Access Compliance Report

Public Rights-of-Way

Intersection ID: 29323	Main Street: SADLER_GLEN_DR	Cross Street: TOM_SADLER_RD	Location: E
ADA ID: 41CC35EF37A7	Ramp Type: Perp	Initial Pass/Fail: Fail	Overall Compliance: No
			Severity Score: 46.25

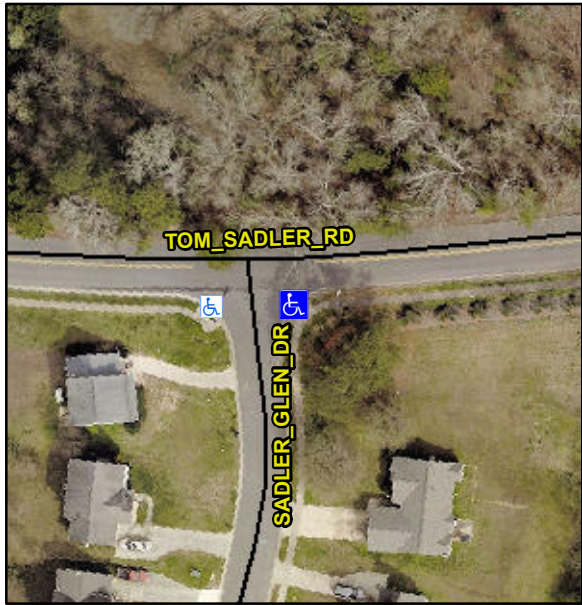
Codes/Mitigation Info/Possible Solution			Field Measurements/Component Compliance													
	Possible Solutions:		Compliance			Description			Data	Compliance			Description			Data
	Remove & Replace Entire Ramp.		N/A	Ramp Length (in)			47.0			No	Ramp Slope (%)			8.4		
			No	Ramp Width (in)			45.5			No	Ramp XSlope (%)			7.3		
			N/A	Flare Type LT			N/A			N/A	Flare Type RT			N/A		
			N/A	Flare Slope LT (%)			N/A			N/A	Flare Slope RT (%)			N/A		
			N/A	Flare Traversable LT?			N/A			N/A	Flare Traversable RT?			N/A		
			N/A	Landing Length (in)			N/A			N/A	DWS Provided?			N/A		
			N/A	Landing Width (in)			N/A			N/A	DWS Contrast?			N/A		
			N/A	Landing Slope (%)			N/A			N/A	DWS Length (in)			N/A		
			N/A	Landing X Slope (%)			N/A			N/A	DWS Full Width?			N/A		
Surveyor Notes:		N/A	N/A			N/A			N/A	DWS Offset (in)			N/A			
PROW/ADA:		Not Found, R304.5.1, R304.2.2, R304.5.3	N/A			N/A			N/A	Gutter Ponding?			N/A
